Appendix I of RNTPC
Paper No. A/YL-PS/622D

Re: ***Section 16 Planning Application for Proposed Temporary Transitional Housing for a Period of 3 Years in Lots 387 S.B ss.1 RP, 387 S.B ss.4 and 387 S.B RP in D.D. 122, and Adjoining Government Land, Ping Shan, New Territories***

RE: Light Village - Planning Application No. A/YL-PS/622 (South Site) and A/YL-PS/623 (North & Middle Sites)

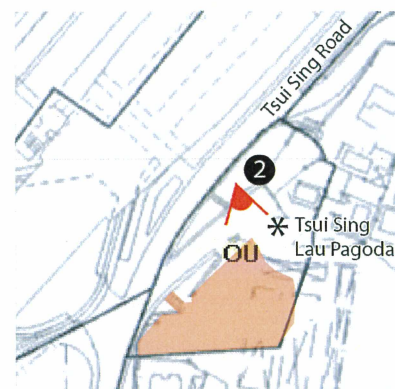
We refer to the Visual Impact Assessment for the South Site. As spoken, the kiosk is added to the photomontage of VP2 (Figure 3) as shown in the attached.

GROUND FLOOR (SOUTH SITE) WITH SETBACK FROM TSUI SING LAU PAGODA COMPARISON

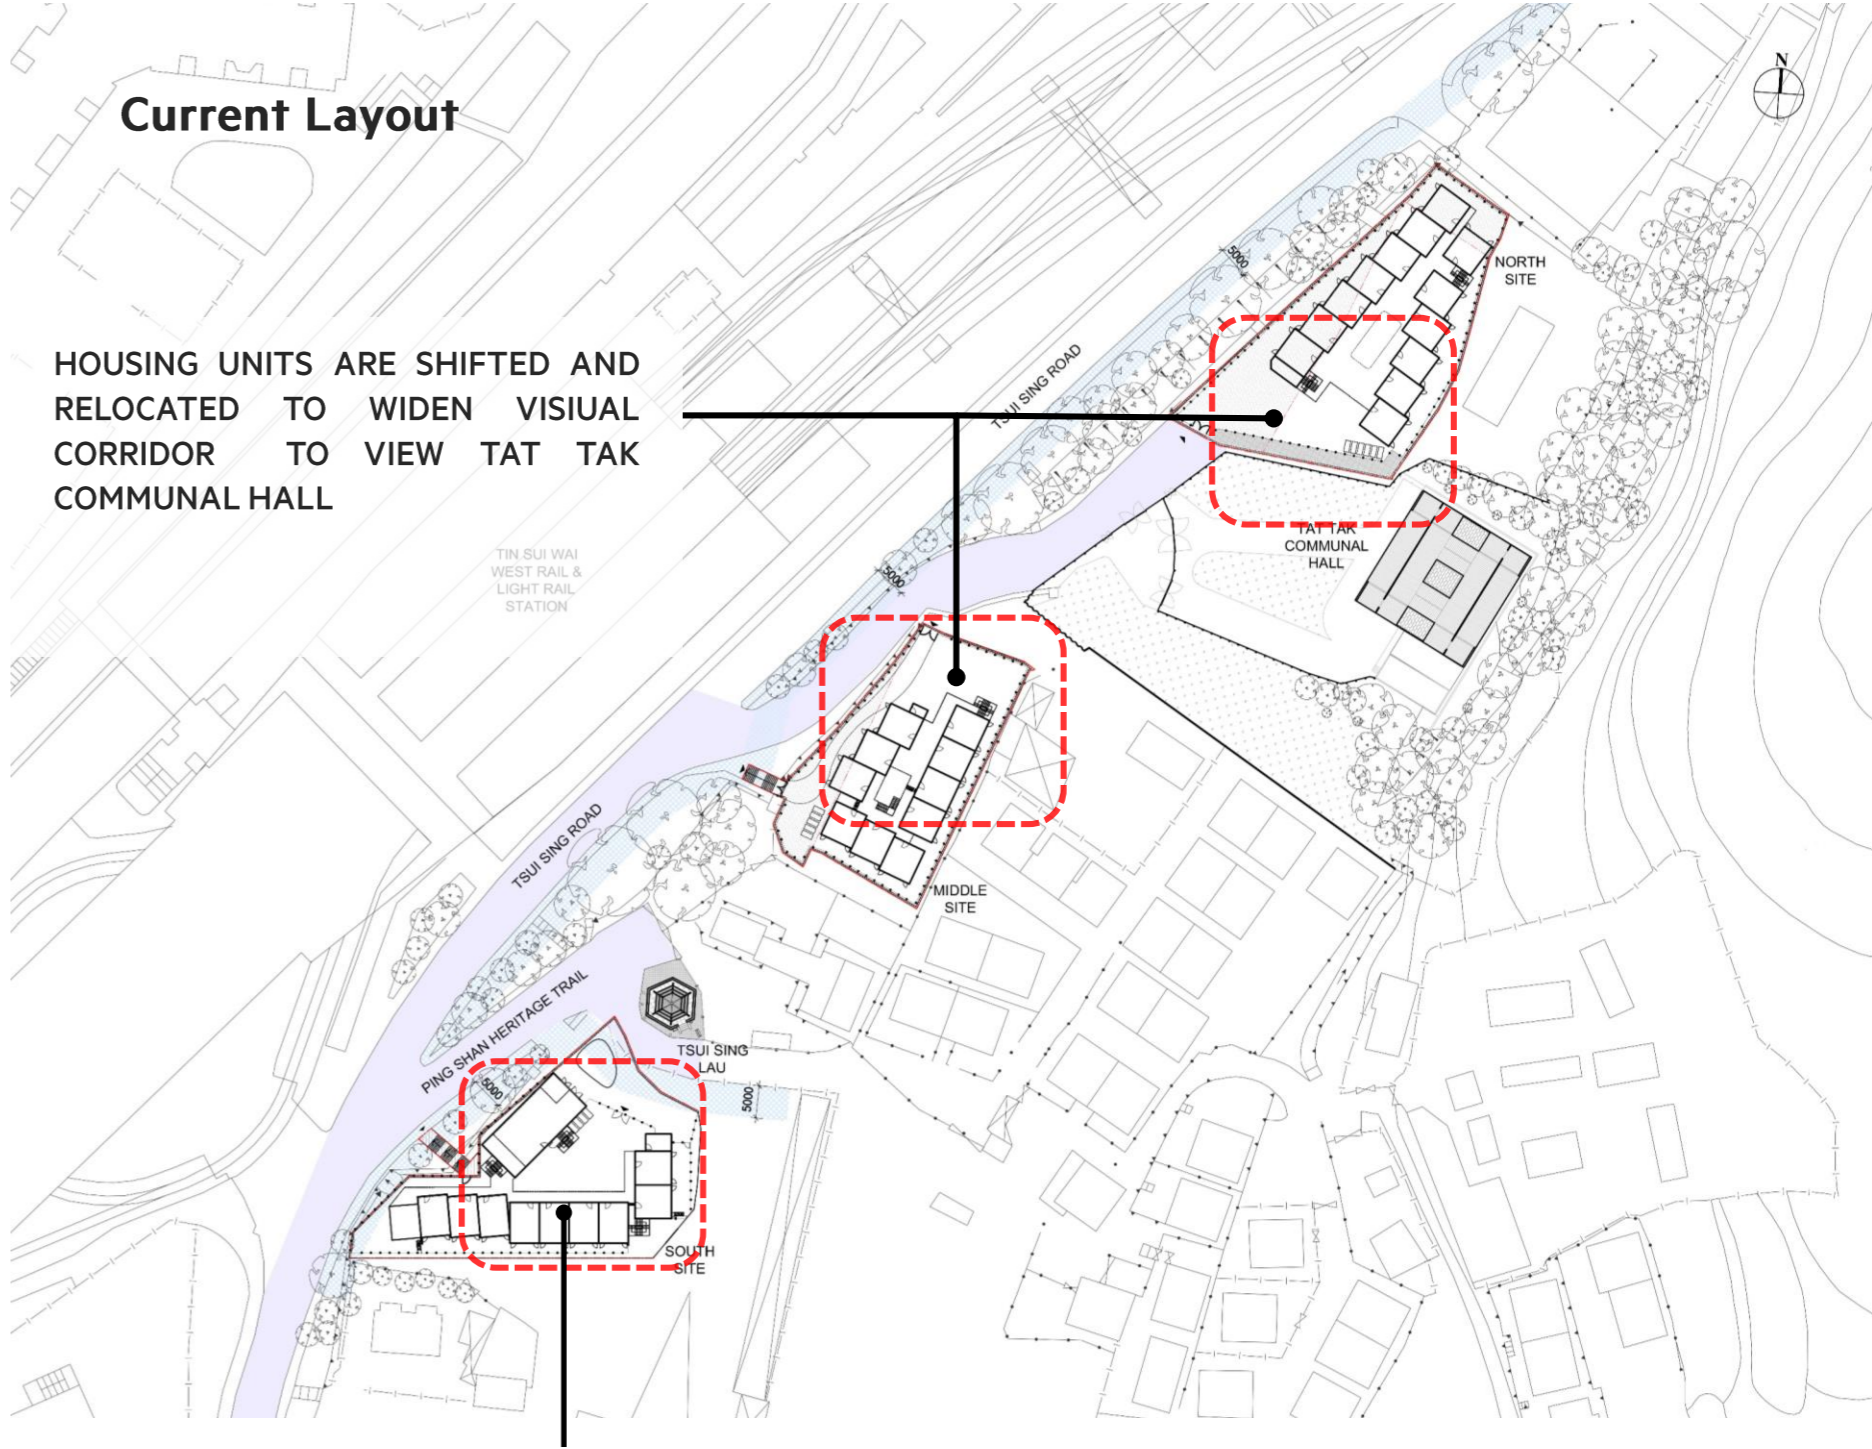
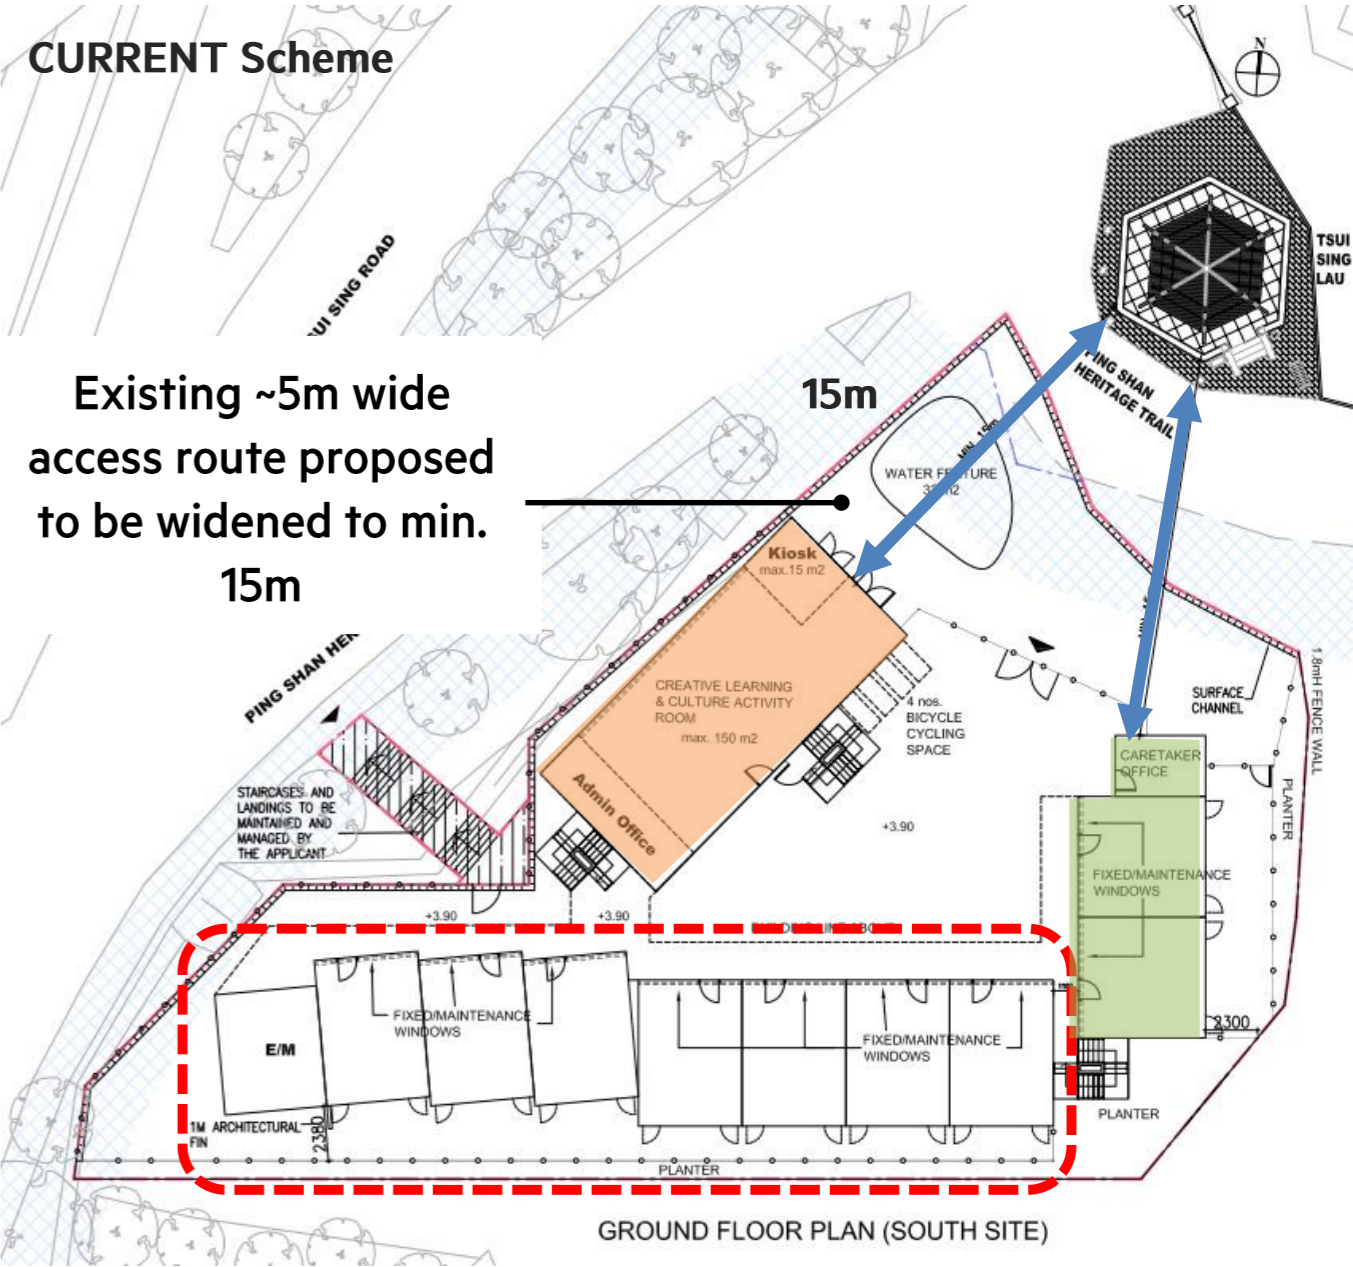
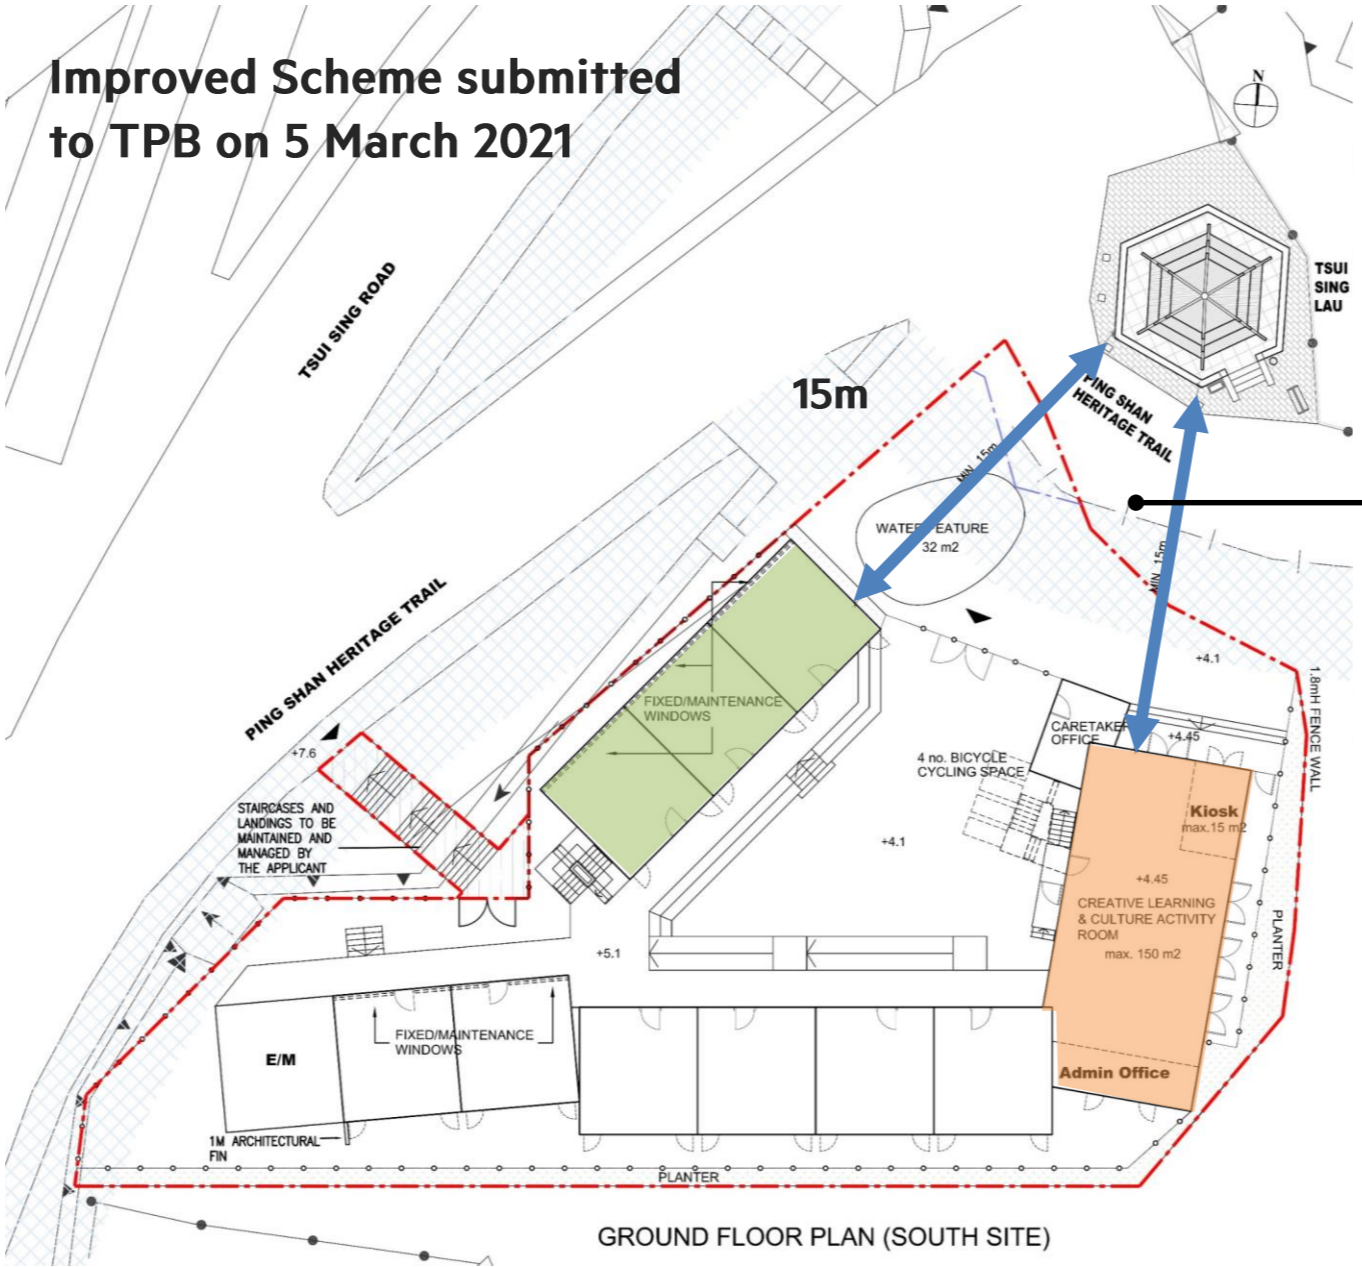
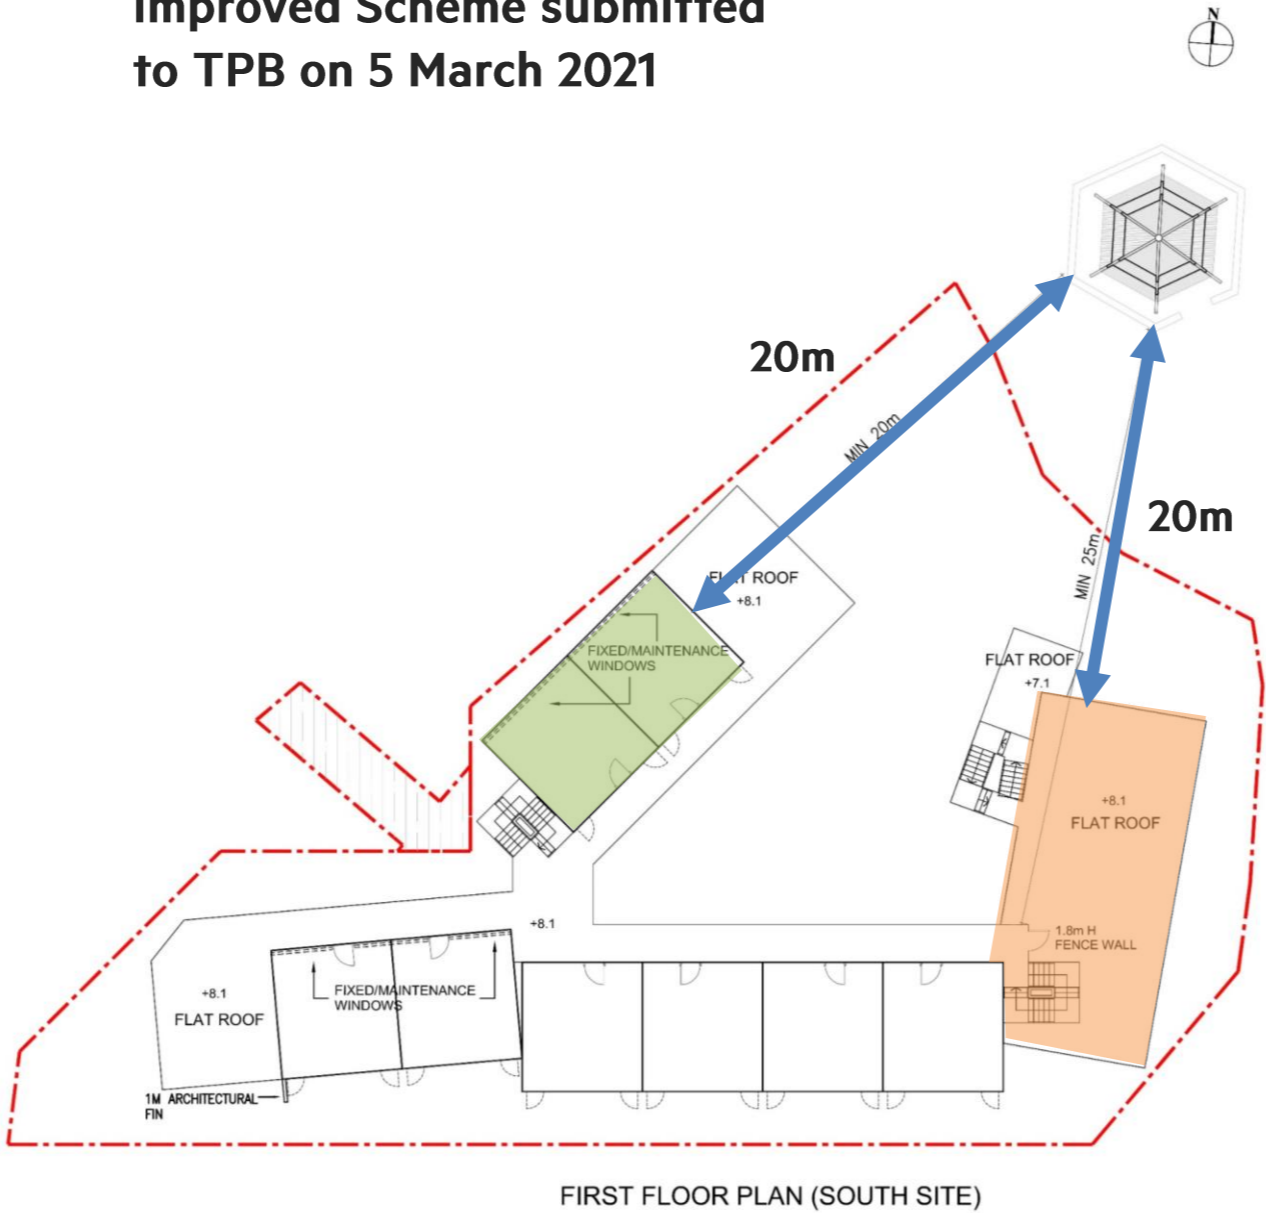
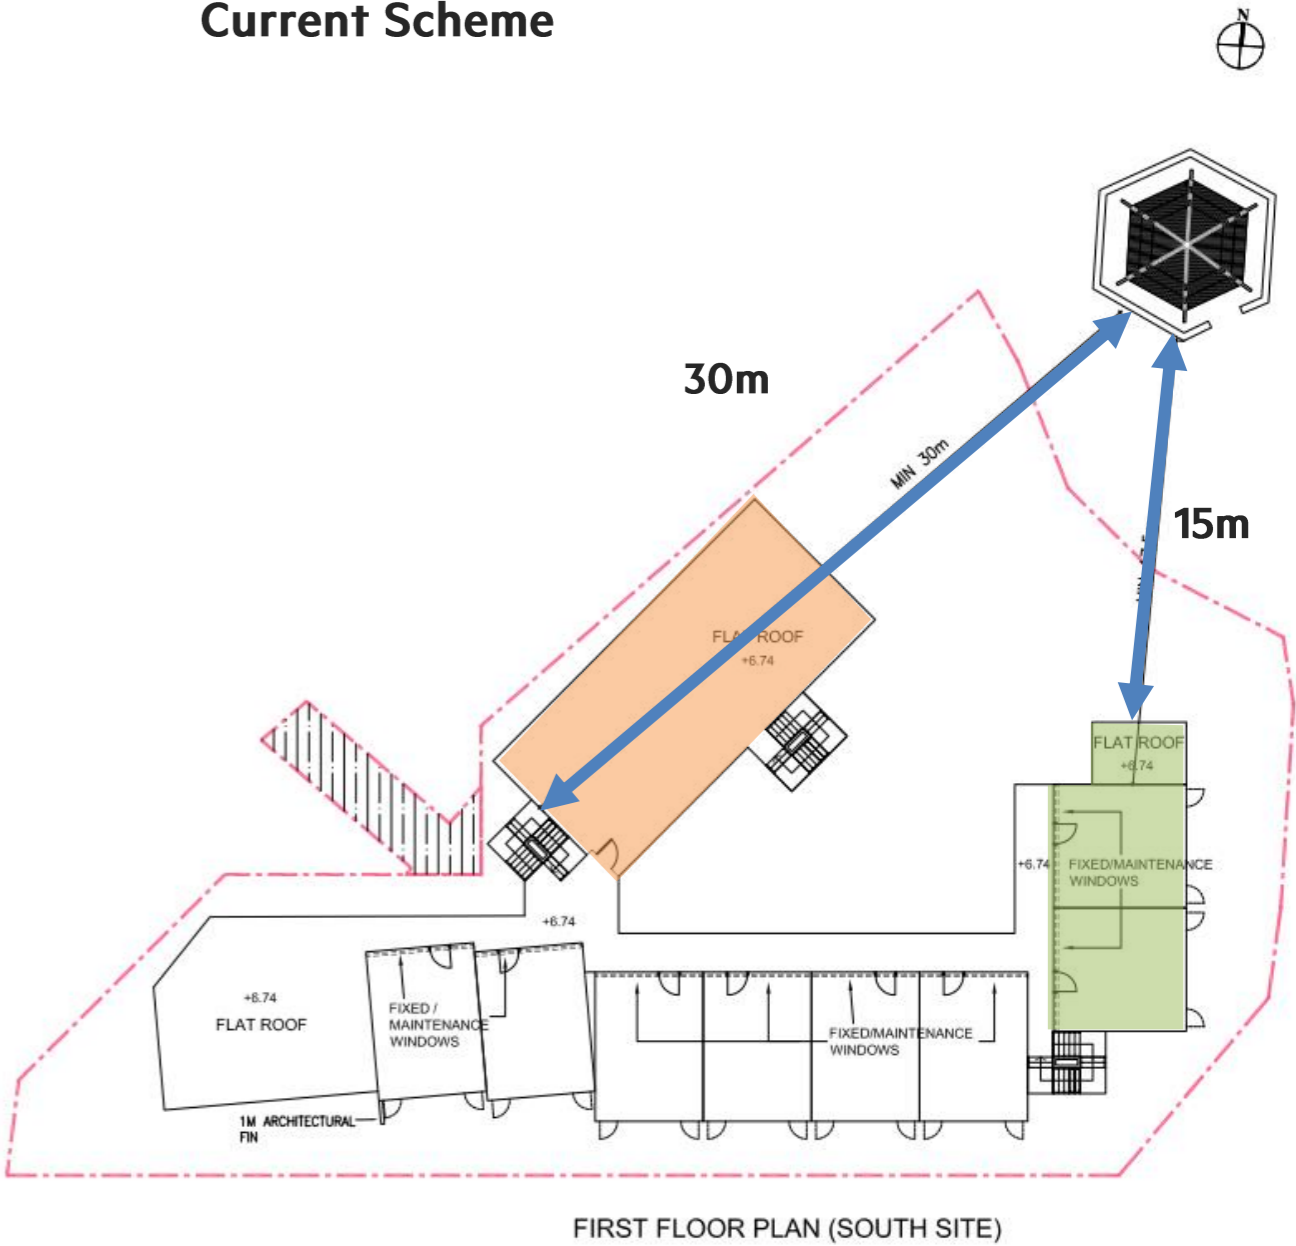
Comments	Response
<p>6. Chief Town Planner/Urban Design and Landscape (Urban Design Unit), Planning Department (Contact Person: Ms. Elizabeth NG, Tel: 2231 5067)</p>	
<p>A/YL-PS/622 (South Site)</p> <p>(i) VP2 in Figure 3 – The proposed development is quite visible to this VP and the existing openness would be significantly altered by proposed building mass. Please re-examine the result of “slightly adverse”.</p> <p>\</p> <p>(ii) VP3 in Figure 4 – Obviously the proposed development would lead to slight changes of the existing sky view. The result of “negligible” should be reassessed to reflect such changes.</p> <p>(iii) Mitigation measures in Para. 6.2 – The effectiveness of proposed mitigation measures such as aesthetic colour scheme in Figure 9, etc. should be illustrated in all photomontages if they are proposed to improve visual quality.</p> <p>(iv) Tsui Sing Lau Pagoda – The applicant should consider to add a viewpoint to assess any visual implications on the pedestrian/visitors near Tsui Sing Lau Pagoda.</p>	<p>i. It is agreed that there is room for improvement. To mitigate the visual impact, building block set back and stepped height design facing the pagoda are proposed. To further minimize the visual impact and improve visual openness, the east wing of the building block is now reduced from 3-storey to 1-storey. The improved scheme allows a more open sky view, a larger water feature and a spacious front yard as compared to the original proposed scheme. With the building setback and water feature at the entrance, as well as the wood and stone colour scheme which echoes the ambience of the pagoda, the visual impact from VP2 would be mitigated to a more acceptable level.</p> <p>ii. As shown in the photomontage of VP3, the proposed development (15.15mPD) is of comparable height to the Thai Restaurant (12.3mPD), the nearby village houses (12.5mPD) and the Pagoda (16.9mPD). It would only bring to slight change to the existing sky view whilst a large portion of the proposed development being screened by the existing vegetation. With the improved scheme, the east wing of the building block has been reduced from 3-storey to 1-storey which the building mass has been further reduced and the village houses at the back could be seen. Hence, very little visual changes would be resulted and there would be no significant visual effects to the VSRs. Considering the transient nature of VP3, the visual impact is considered negligible.</p> <p>iii. Relevant photomontages for VP2, VP3 and VP7 of the South Site are revised and enclosed in Attachment 2.</p> <p>iv. A viewpoint taken from Tsui Sing temporary car park (VP8) is added. VP8, located about 70m from the South Site, is a short distance view overlooking the pagoda and the Thai Restaurant. The lower part of the Thai Restaurant is being blocked by the fence wall of Elle Garden. Further back is the Ping Wu Garden with Tin Shui Wai MTR Station, Tin Yiu Estate and open sky view as the backdrop. There are existing temporary structures that have blocked the lower part of the pagoda. The VSRs are mainly the car park users tended to have short stay, viewer population and visual sensitivity of</p>

- MIN. 15m SEPARATION FROM PAGODA ON G/F
- LOCATION OF CREATIVE LEARNING & CULTURAL ACTIVITY ROOM AND HOUSING UNITS ARE SWAPPED
- DIMENSION OF HOUSING UNITS ARE ADJUSTED TO MAINTAIN SEPARATION FROM TSUI SING LAU PAGODA
- AREA OF TYPICAL UNIT REMAINS UNCHANGED

- MIN. 15-30m SEPARATION FROM PAGODA ON 1/F
- FLAT ROOF AT WEST WING REDUCES VISUAL OBSTRUCTION OF VIEWING TSUI SING LAU PAGODA FROM TSUI SING ROAD

- MIN. 17.5-30m SEPARATION FROM PAGODA ON 2/F
